**Department for Levelling Up,
Housing and Communities**

30 November 2022

**Notice of corrections to Approved Document B (ADB) 2019 edition
incorporating 2020 and 2022 amendments**

The following Diagram 2.7 (Fire resistance of areas near to external stairs) in ADB Volume 1 2019 edition incorporating 2020 and 2022 amendments is withdrawn and no longer approved:

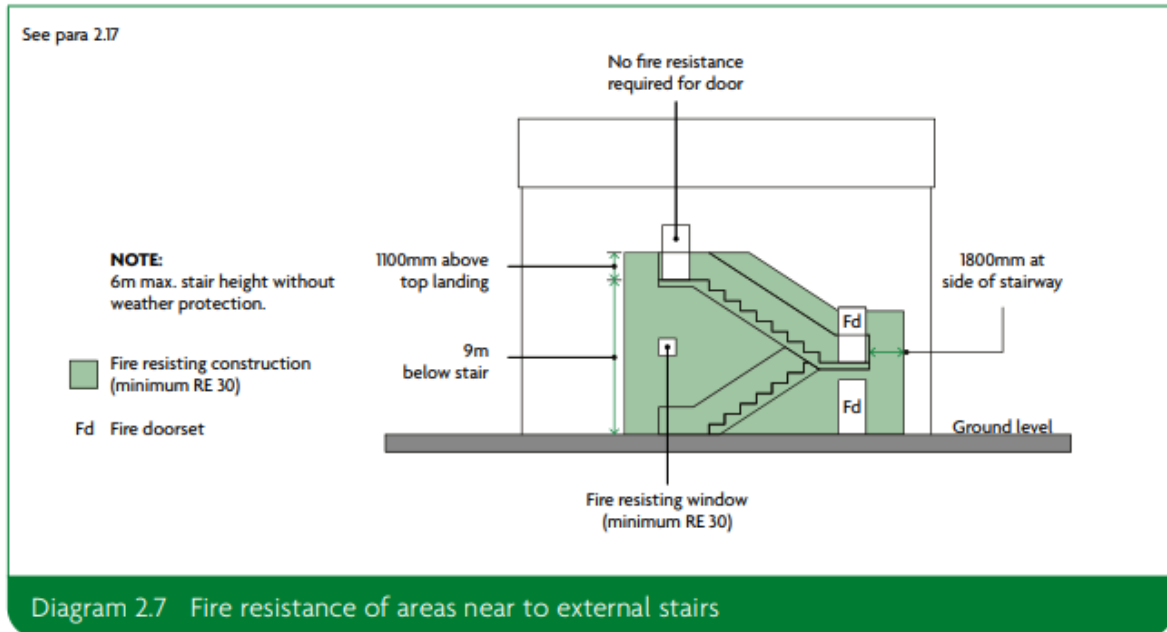
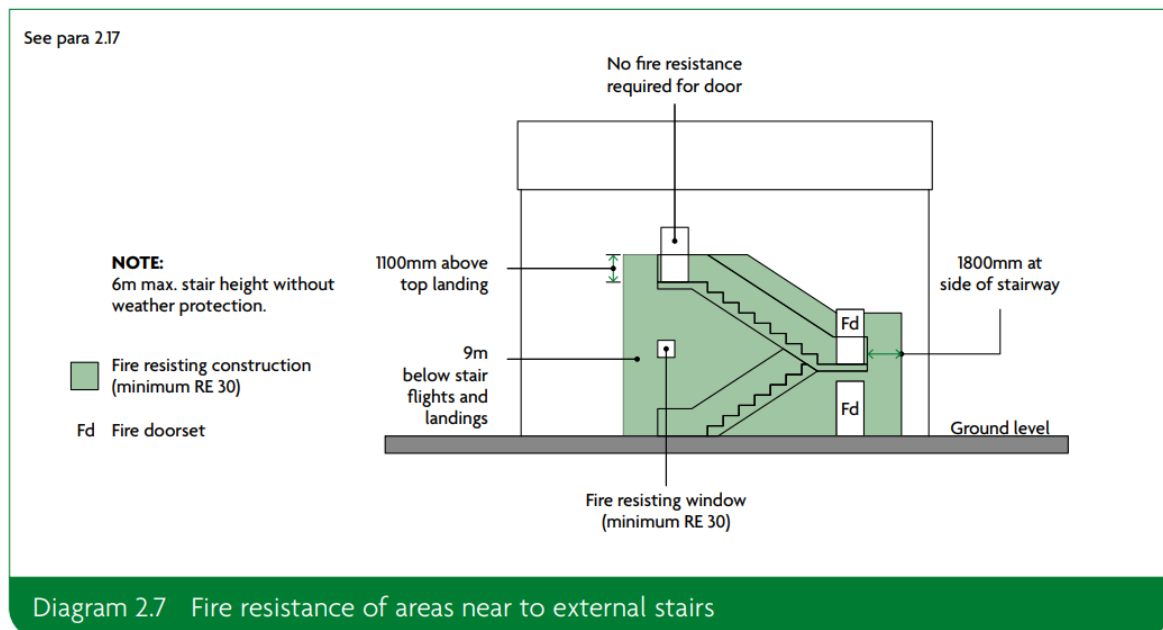
6. External stair diagrams updated

The diagram showing the areas of fire resistance of areas near to external walls has been updated to bring further clarification.

Diagram 3.11 Fire resistance of areas near to external stairs

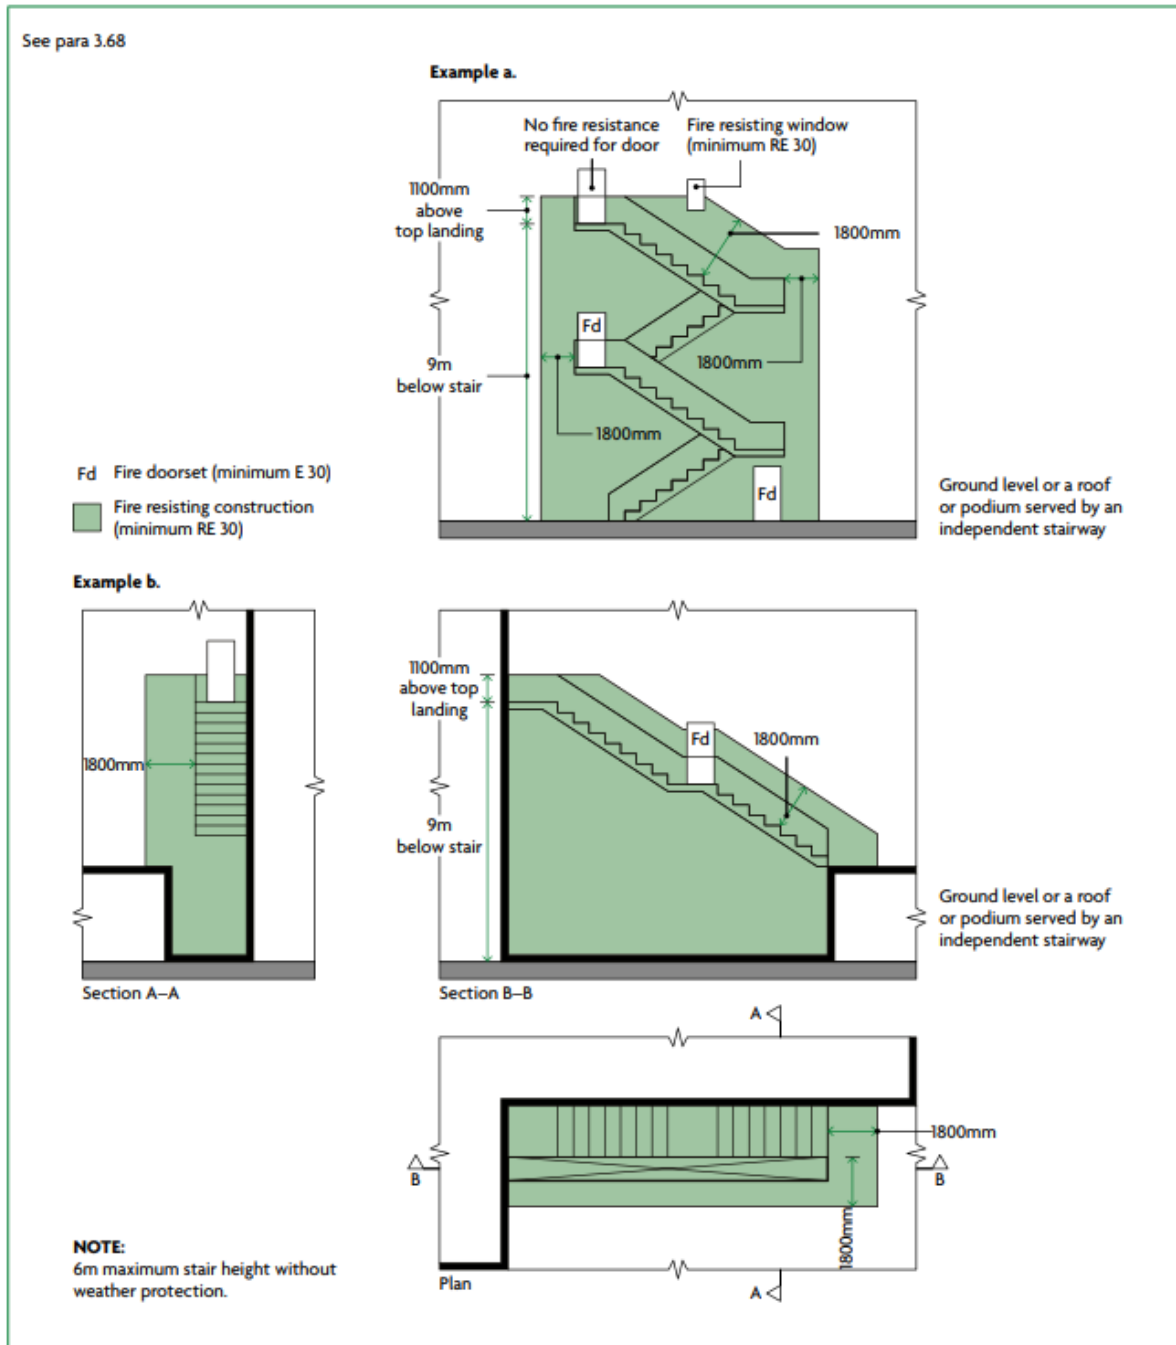
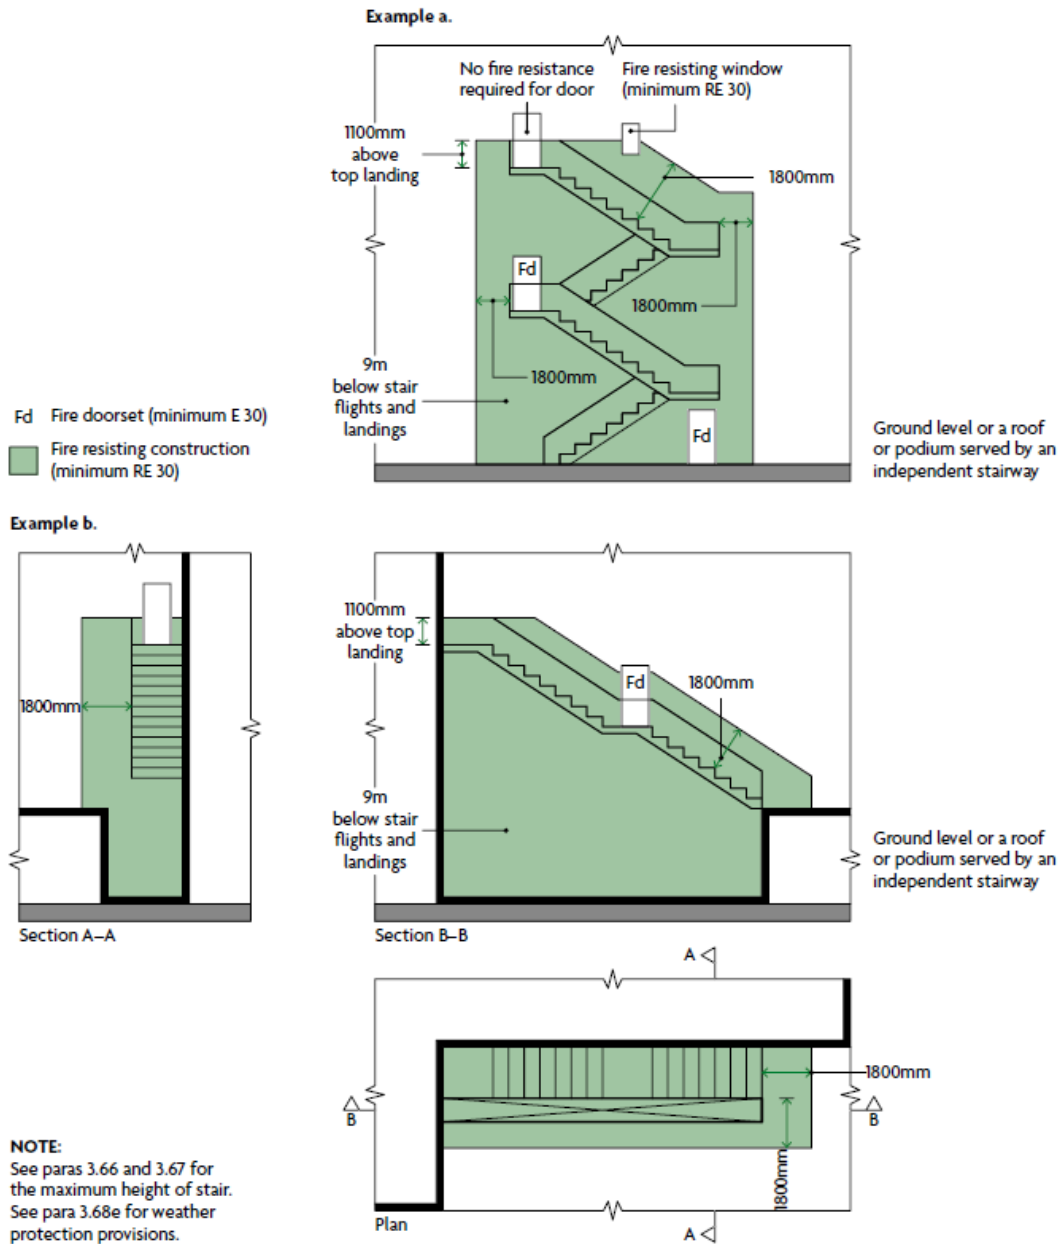
The following Diagram 3.11 (Fire resistance of areas near to external stairs) in ADB Volume 1 2019 edition incorporating 2020 and 2022 amendments is withdrawn and no longer approved:

Diagram 3.4 Fire resistance of areas near to external stairs

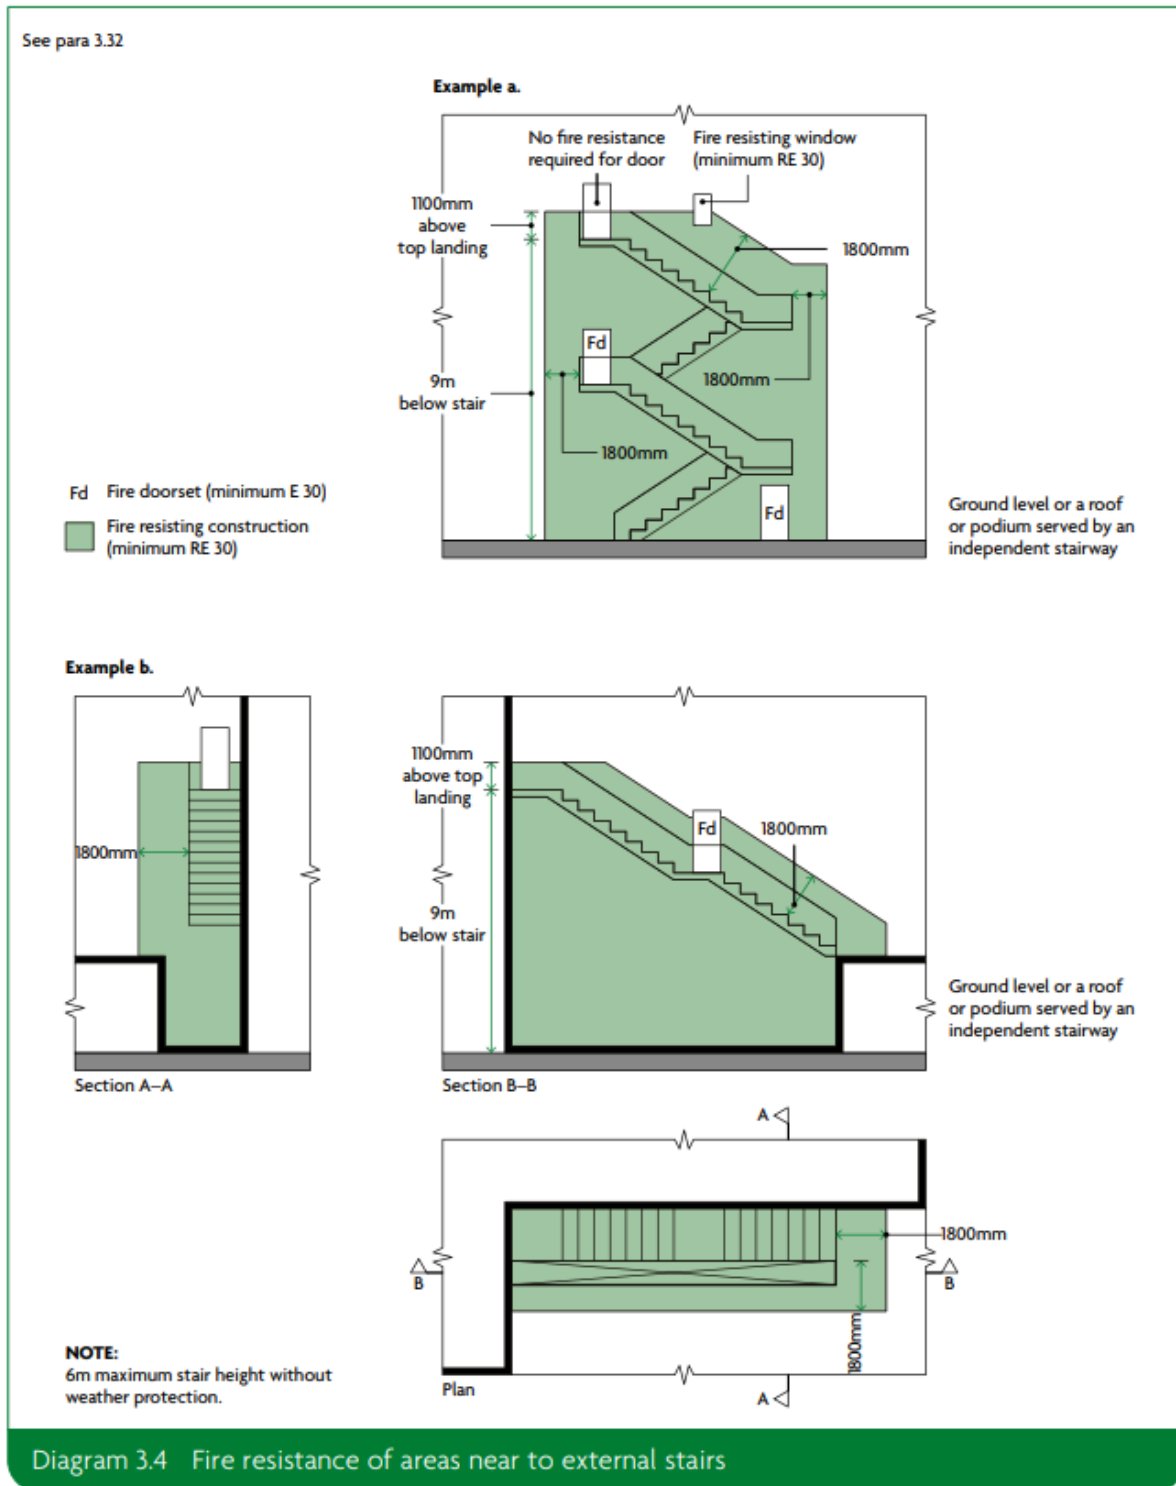
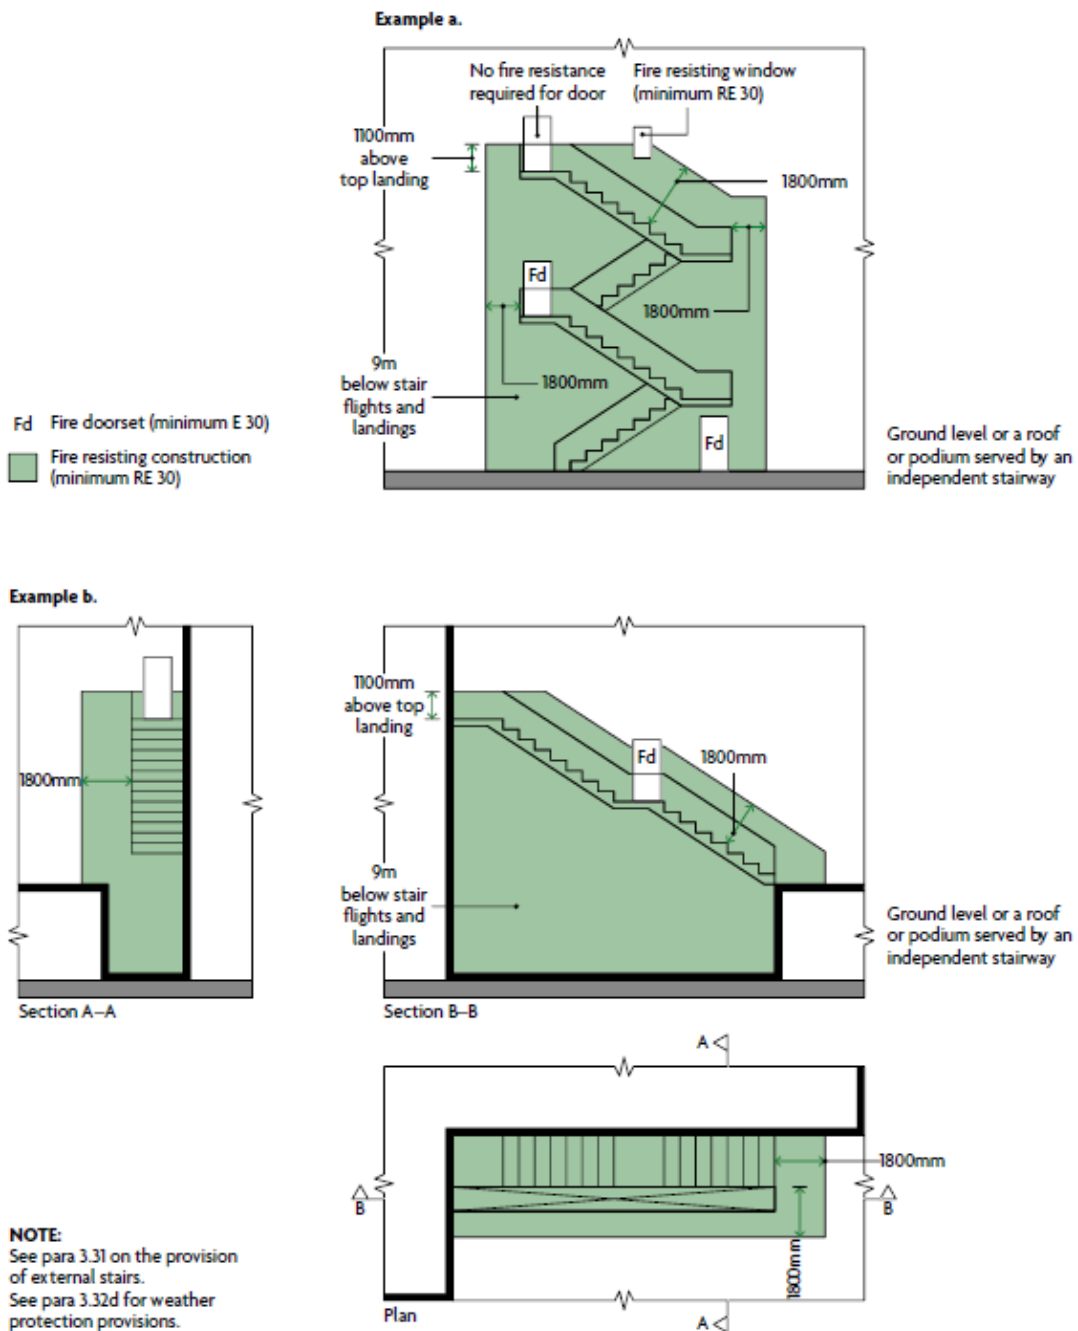
The following Diagram 3.4 (Fire resistance of areas near to external stairs) in ADB Volume 2 2019 edition incorporating 2020 and 2022 amendments is withdrawn and no longer approved:
